MILWAUKIE PLANNING COMMISSION
PUBLIC HEARING
TUESDAY, MARCH 12, 1991

PROPOSAL: Preliminary Plat for a 6-lot Subdivision in R-7 (S-91-01).

5.2 APPLICANT: Guido and Wilma Bocci
PROPERTY OWNER: Guido Bocci
LOCATION: 11708 SE Home Avenue (Tax Lots 300 and 400 of Tax Map T1S, R2E, 31CA)
PROPOSAL: Preliminary Plat for a 22-lot Subdivision in R-7 (S-91-02).

CITY OF MILWAUKIE
COMMUNITY DEVELOPMENT DEPARTMENT
STAFF REPORT

PRELIMINARY PLAT OF TORINO I PHASES VI & VII & VIII

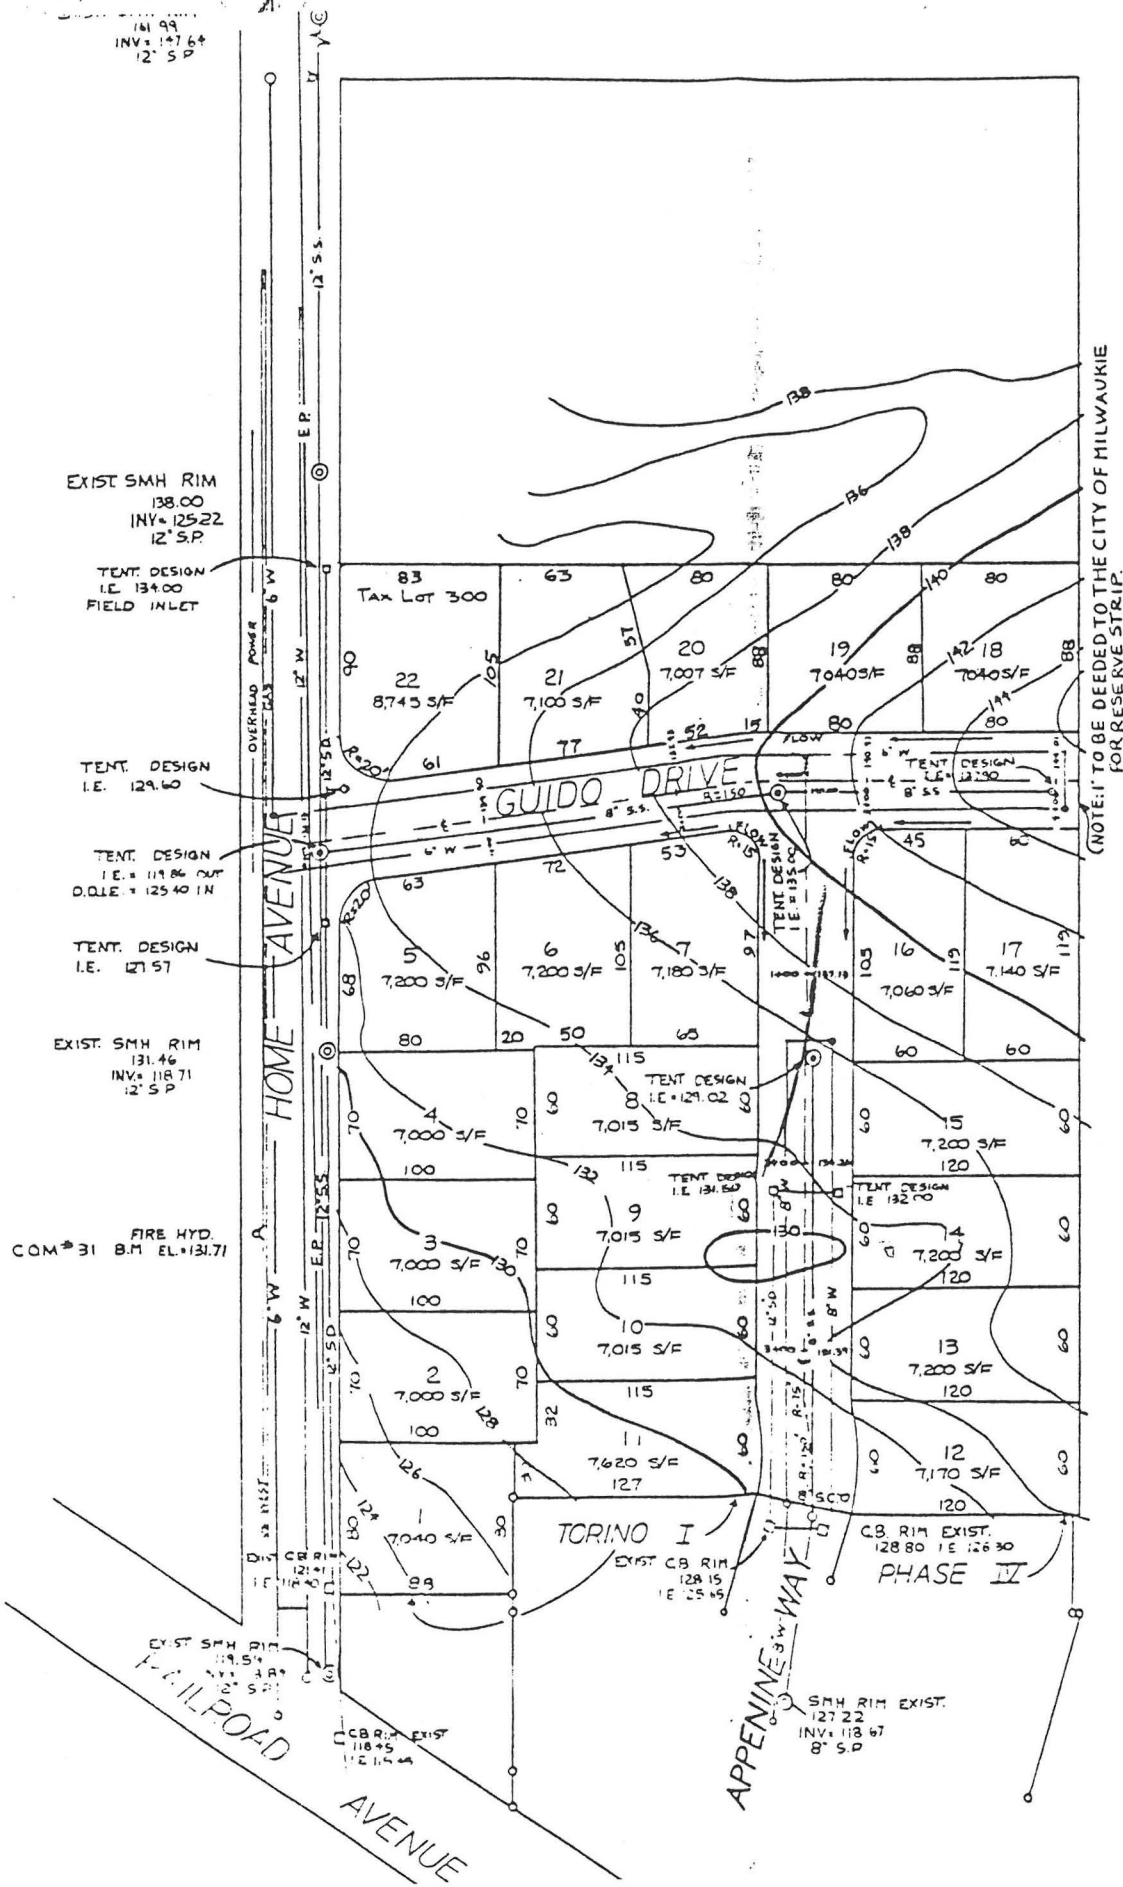
12. The preliminary plat for S-91-02 shows (in dashed lines) a potential extension plan for Guido Drive. This extension plan is provided only for illustrative purposes. Actual extension location for Guido Drive would be determined as part of a development proposal for those properties to the east of the subject property.

This letter is regarding the proposed development of Tax Lot(s) 300, 390, and 400 of Tax Map T1S, R2E, 31CA on Home Avenue. The development as it is proposed prevents future development of the west end of my lot (#5901). Because of the topography of lot #5901, the sewer line on Wood Avenue is not deep enough to provide drainage.

Please reconsider the proposal and provide road and sewer access to the west end of our lot (5901).
